UNITED STATES PATENT AND TRADEMARK OFFICE

APPLICATION NO.	FILING DATE	FIRST NAMED INVENTOR	ATTORNEY DOCKET NO.	CONFIRMATION NO.
10/625,619	07/23/2003	Wayne Tjeerdsma	23-0390	8073

Office Action Summary

DETAILED ACTION

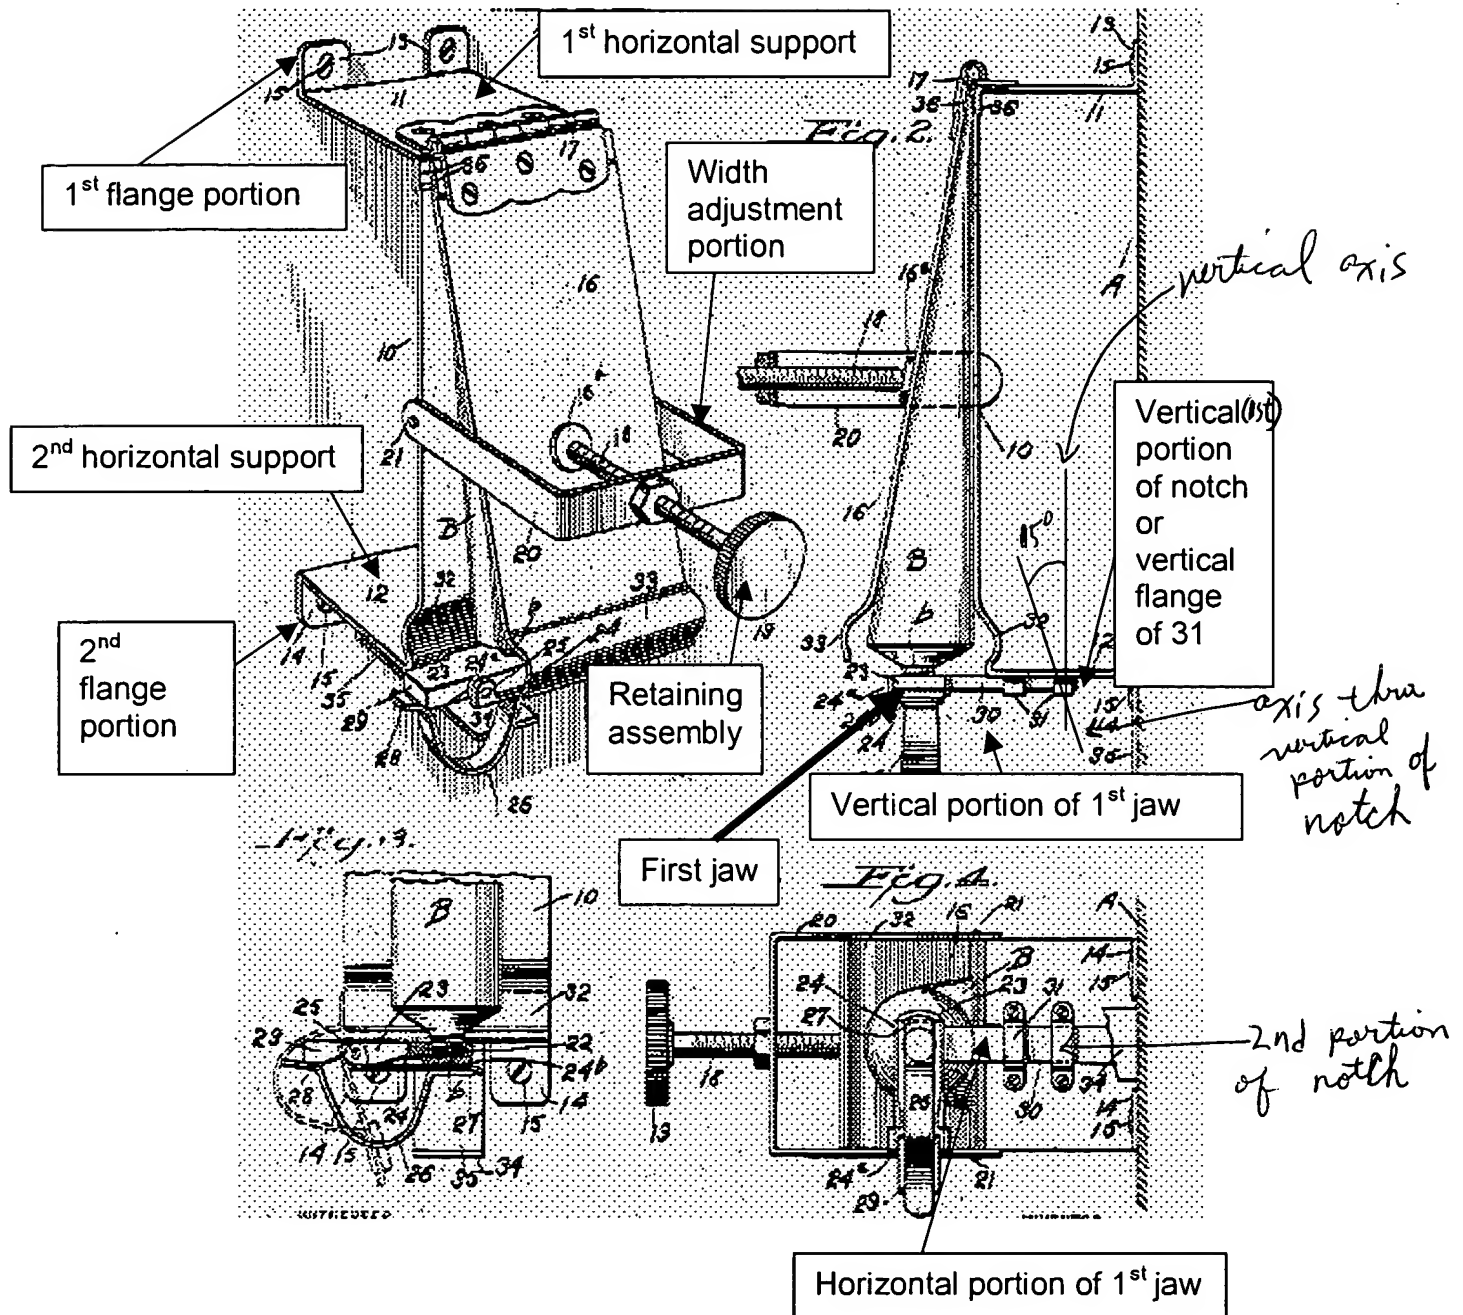
Claims 1-3 and 7-10 are rejected under 35 U.S.C. 102(b) as being anticipated by Roach (US patent no. 1,320,275). Roach discloses all the claimed features of applicant's invention as illustrated below. Furthermore, regarding claim 9, there is an axis that runs through the first portion (vertical portion of bracket 31) of the notch (formed by U-shaped bracket 31) that is 15 degrees from the vertical, and Roach shows a second portion of the notch at right angles to the first portion (see illustration below). Regarding claim 10, Roach shows the second jaw with coupling portion (17) and lever (16) extending downwardly, and a width adjustment portion (20) being slidably coupled to the lever (16) via retaining assembly (19).
